### **ADDENDUM #2-A**

#### **Bid 100-19 T Building – New Storage Buildings Project**

#### **Palomar Community College District**

# DriftTrak® DTSLB

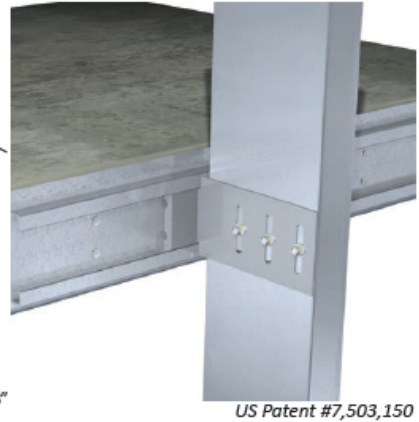
- (6) QUESTION: The curtain wall clips, DTSLB, called out in 5/S1.4 are not conducive for the application drawn. The DTSLB uses a continuous channel to hold the clips rather than welding. No such channel is indicated. Please see attached catalog cut.

I think what you drew was a Simpson SC Bypass Framing Slide-Clip Connector. Is that what you want?

*RESPONSE: In detail 5/S1.4, the continuous channel is labeled as "DTSLB Track", which is shown being welded to a cont. 1/4" bent PL. The curtainwall clips are attached to this DTSLB track.*
